ADDENDUM

PROJECT: Eastridge Presbyterian Church
Phase II - Education Wing Renovation
Lincoln, Nebraska

AD-2

DATE ISSUED: Friday, May 4, 2012

Drawing # C-102.2

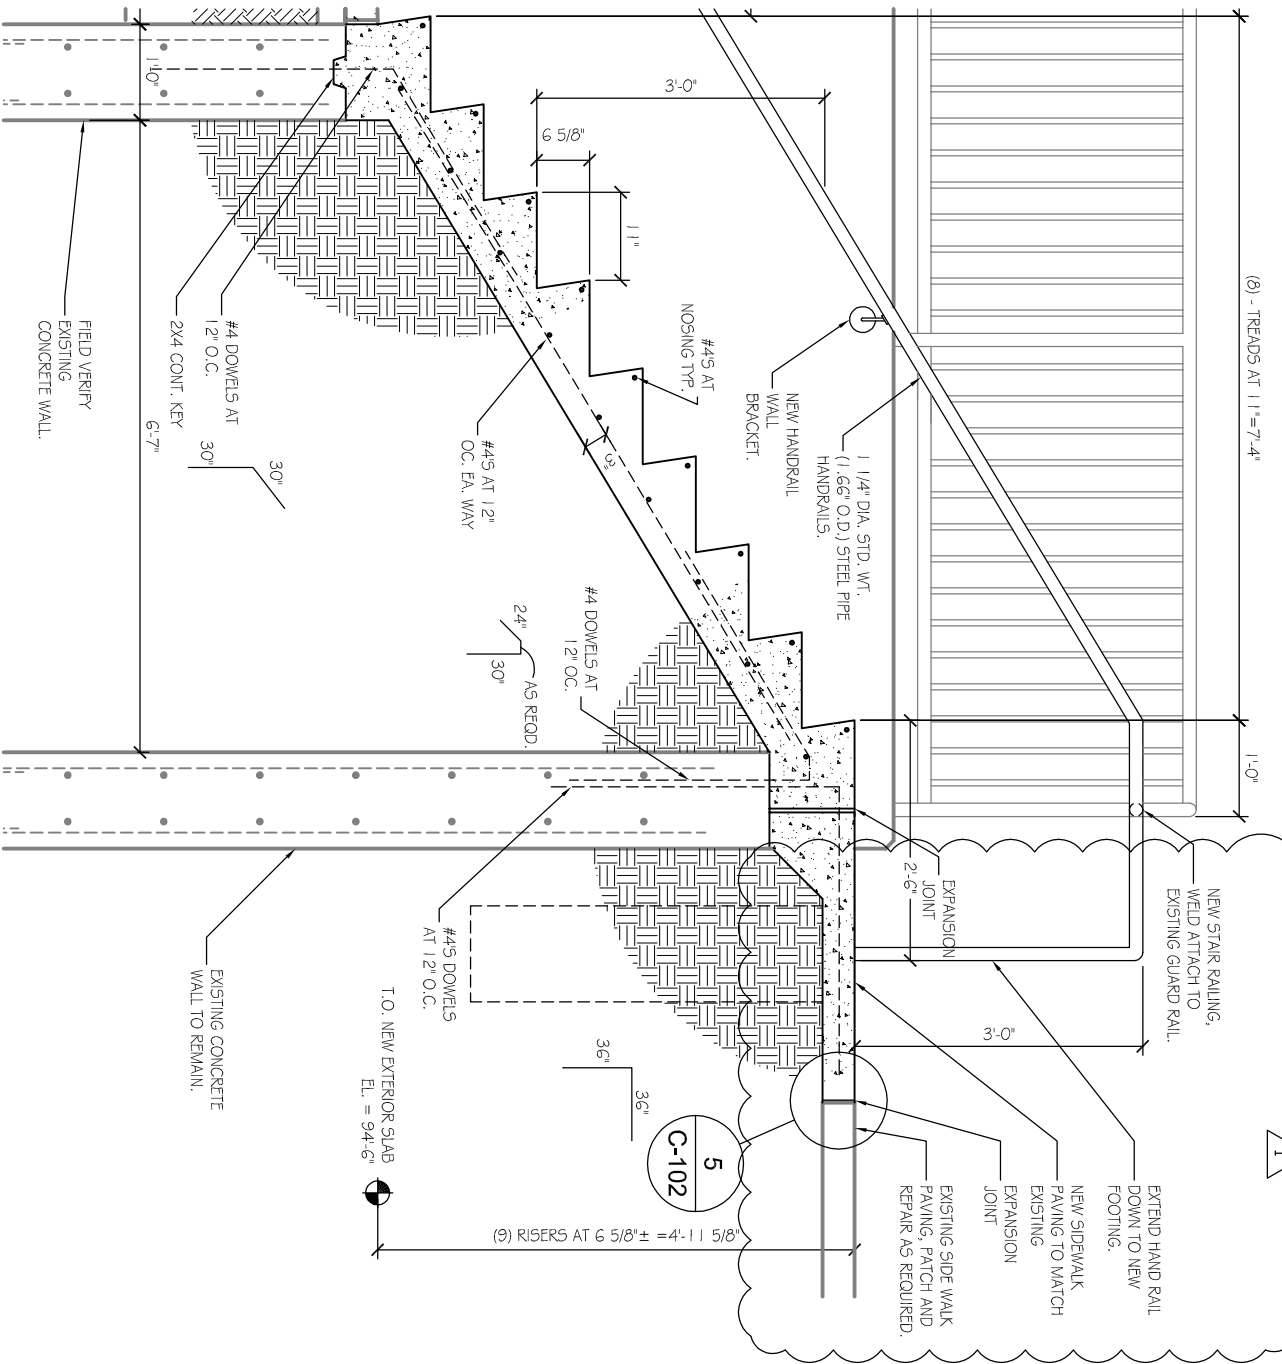
In reference to drawing Sheet C-102, add metal gate with self closing hinges to top of exterior stairs as shown in attached supplemental drawings C-102.1, C-102.2, C-102.3, and C-102.4.

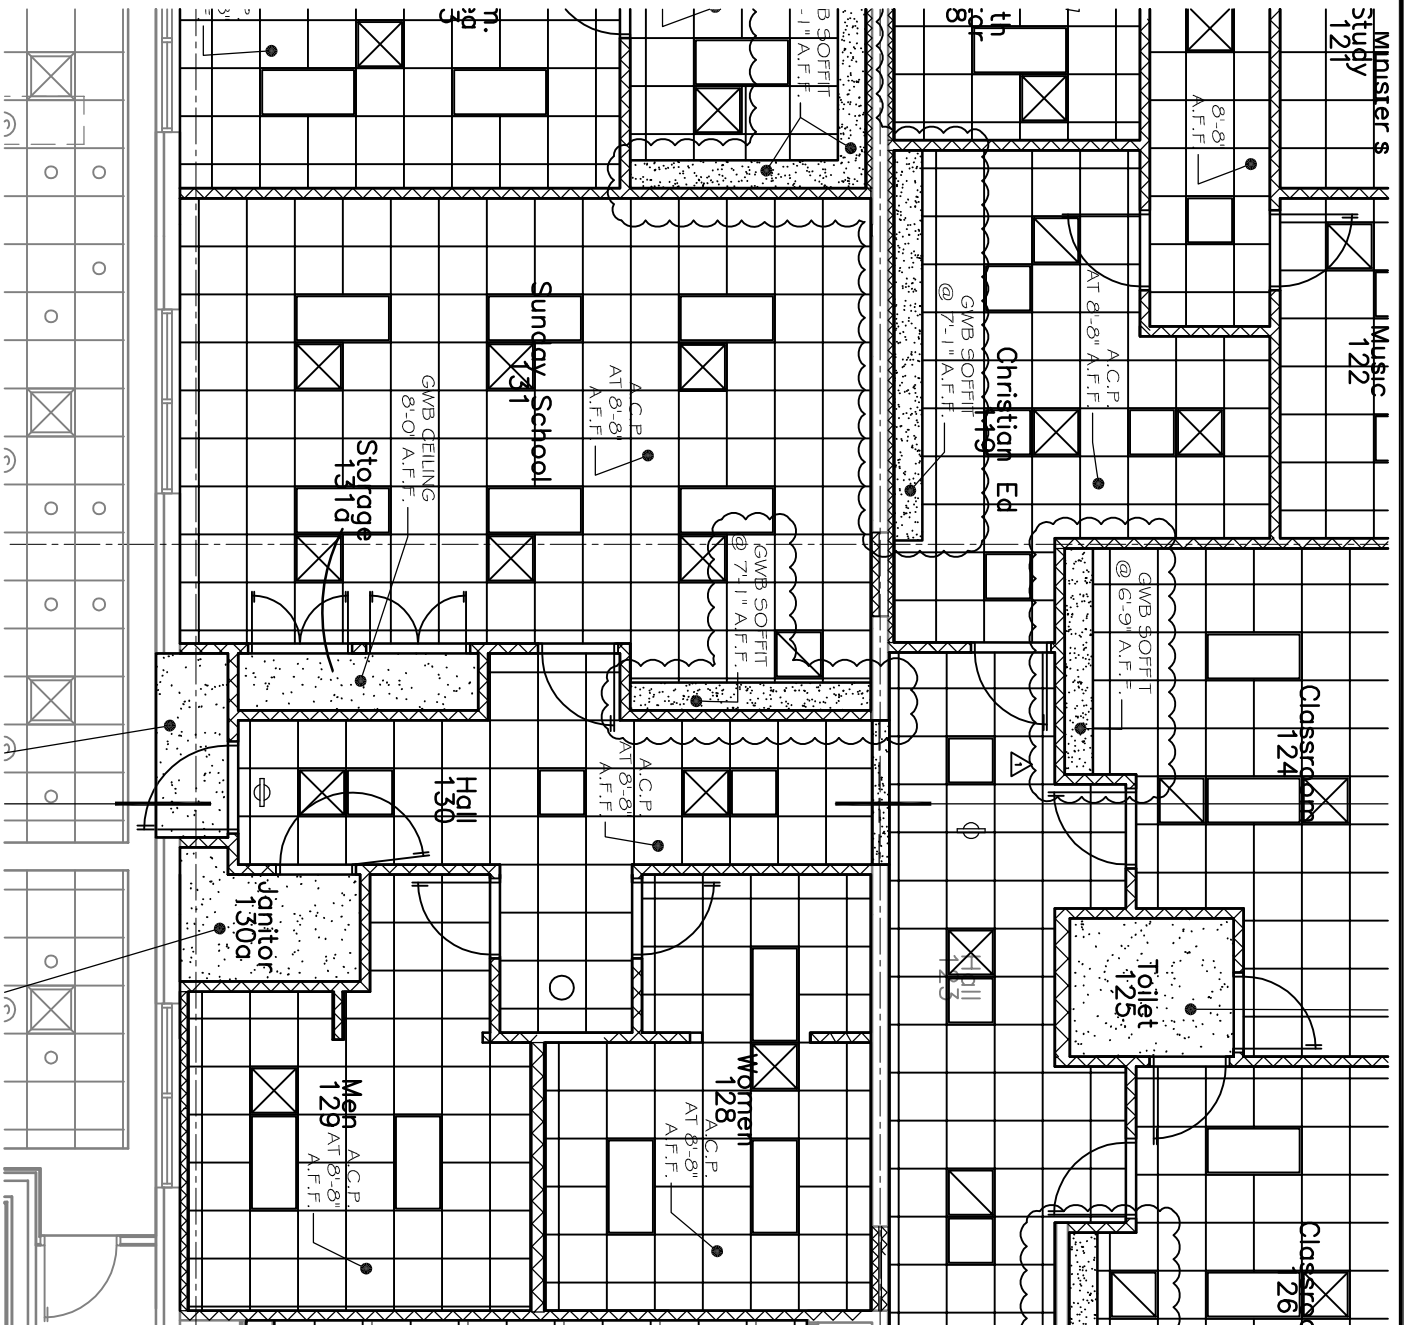
In reference to drawing Sheet A-103, add soffits in the ceilings as detailed on attached supplemental drawings A-103.1, A-103.2, and A-103.3.

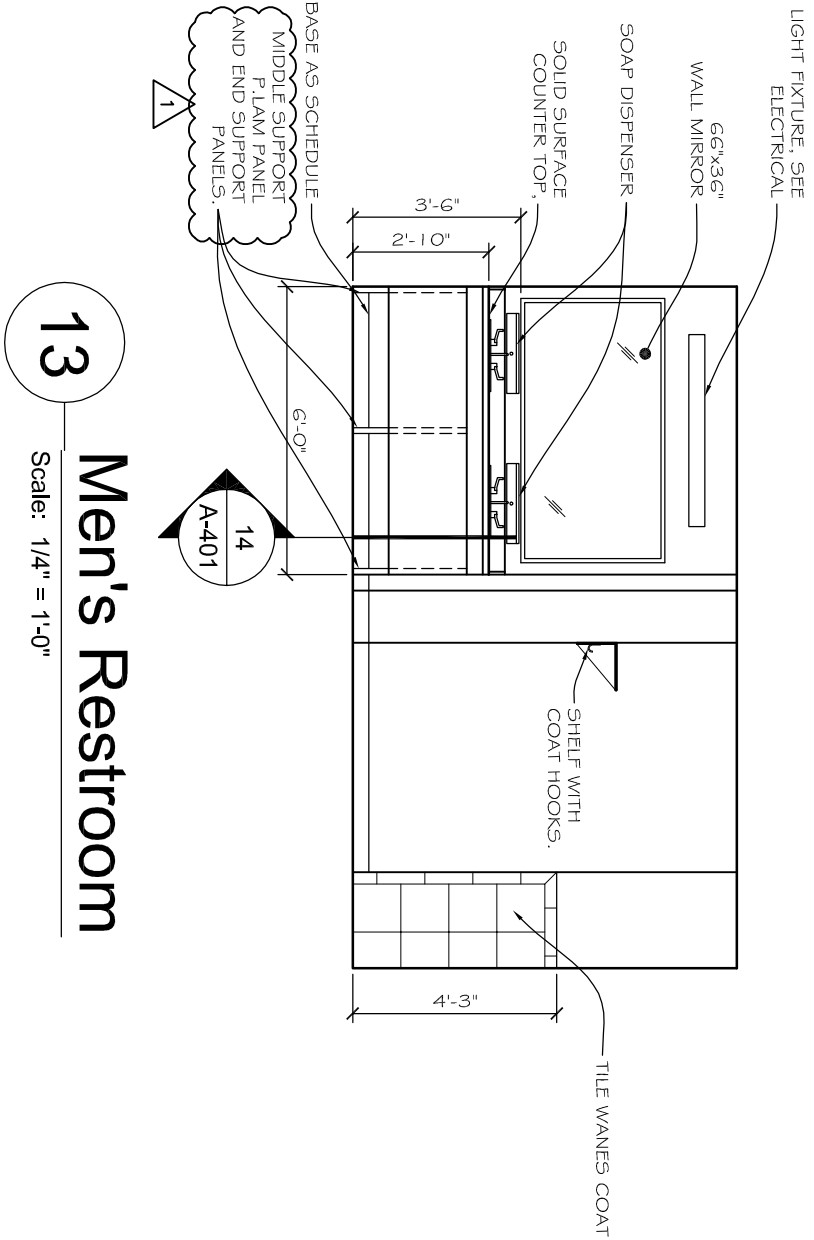
In reference to drawing Sheet A-401, for the Women's restroom 128 and Men's restroom 129, add mid span support panel at the sink as detailed on supplemental drawings A-401.1, A-401.2, and A-401.3.

From Sheet: A-401 for CA use:
 Drawing # A-401.4

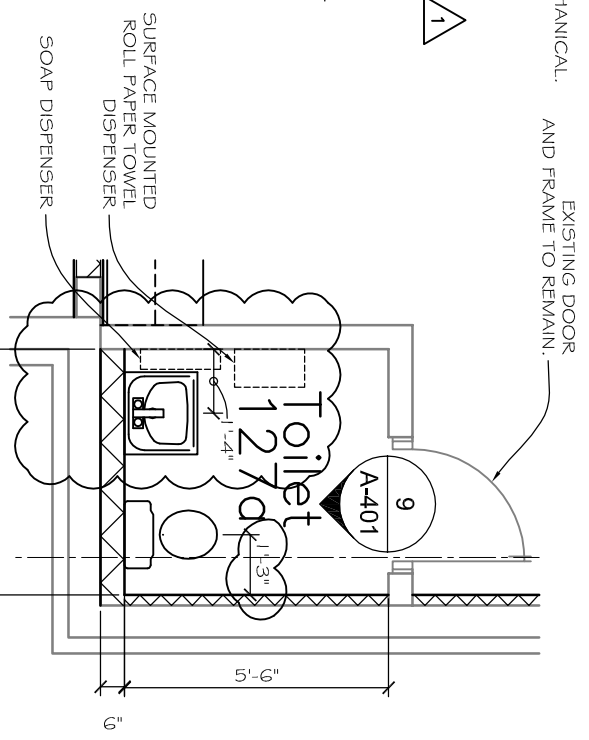
In reference to drawing Sheet A-401, for the toilet room 127a modify the fixtures to be child height and as detailed in supplemental drawings A-401.4.

From Sheet: I-101 for CA use:
 Drawing # I-101.1

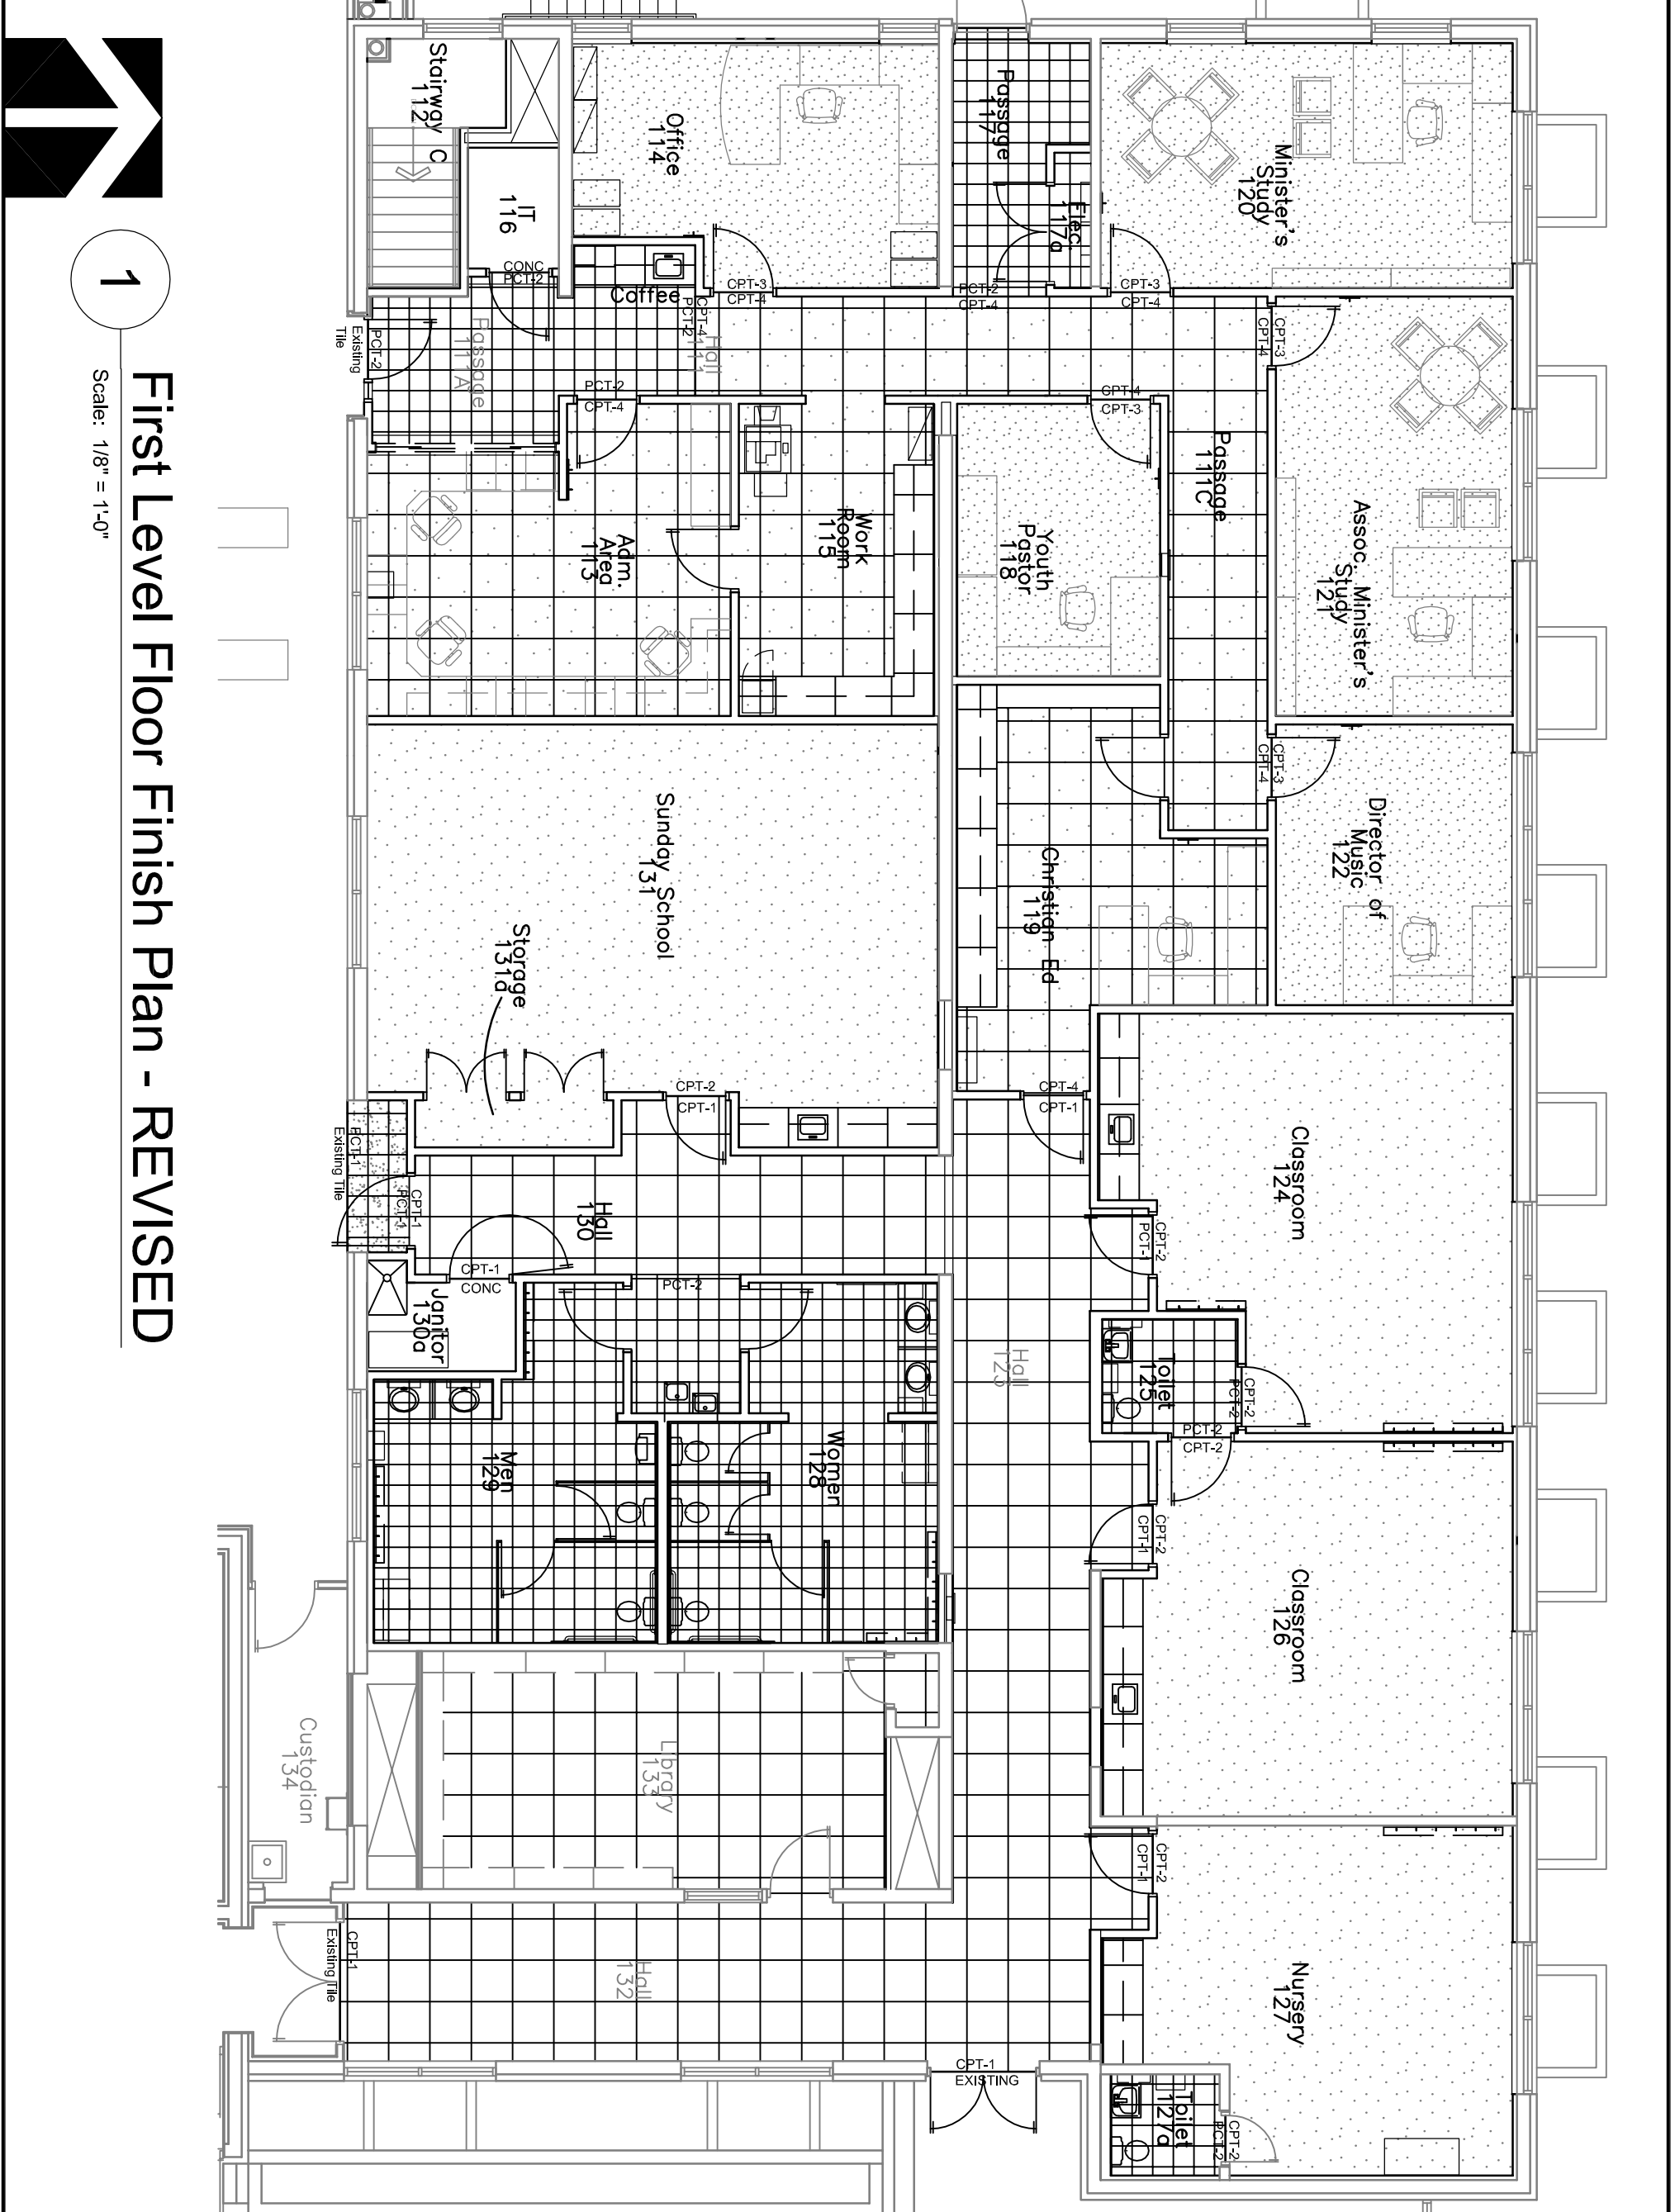
In reference to drawing Sheet I-101 (now obsolete) please see the attached REPLACEMENT drawings:

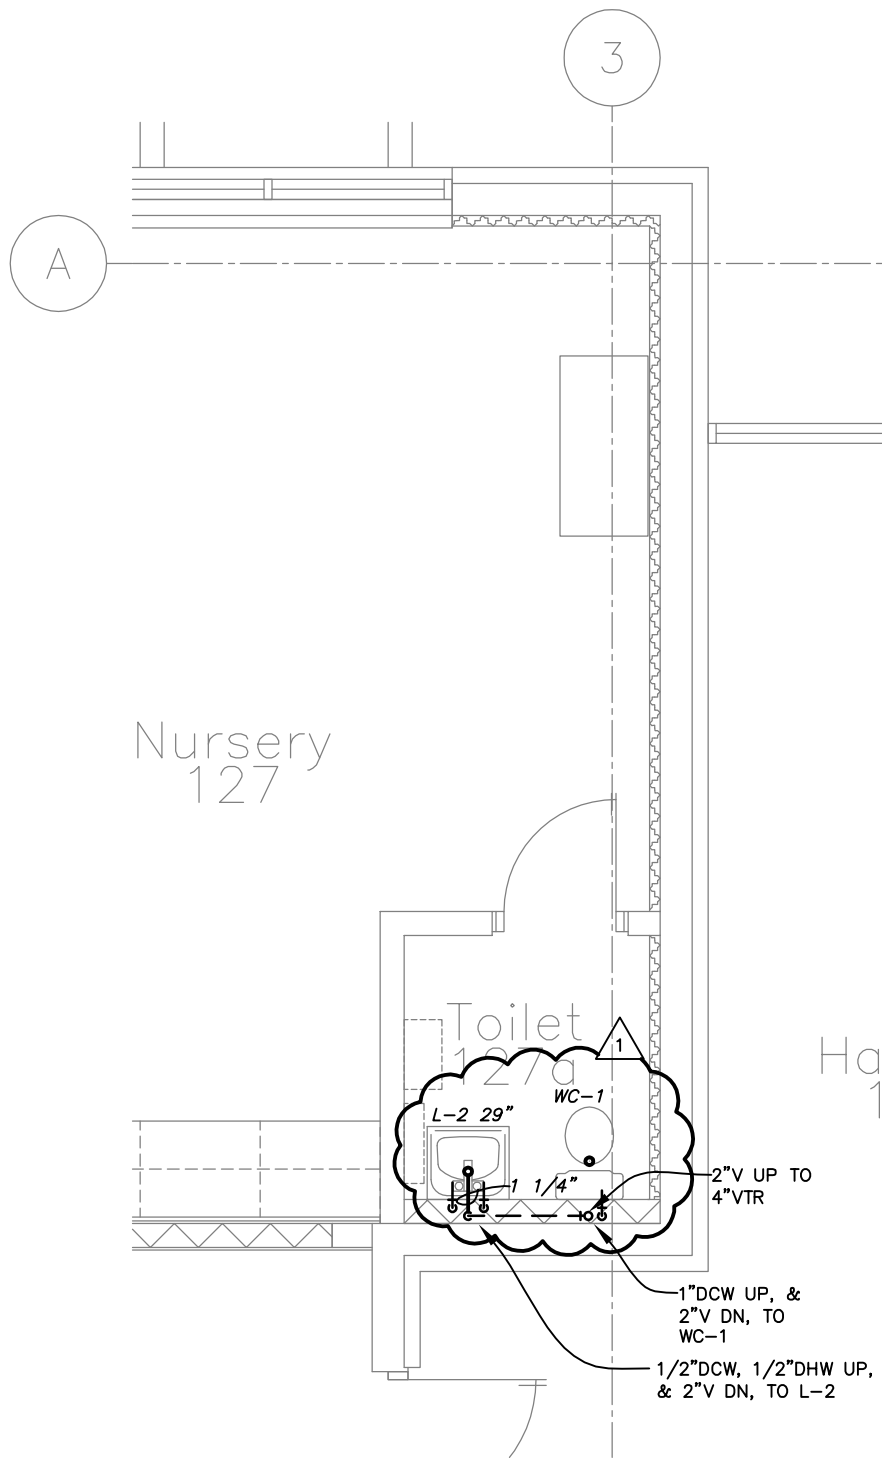
In reference to drawing Sheet P-104, the water closet in Toilet 127A and Toilet 125 shall be labeled as WC-1. Please refer to attached drawing P-104.1 and P-104.2.
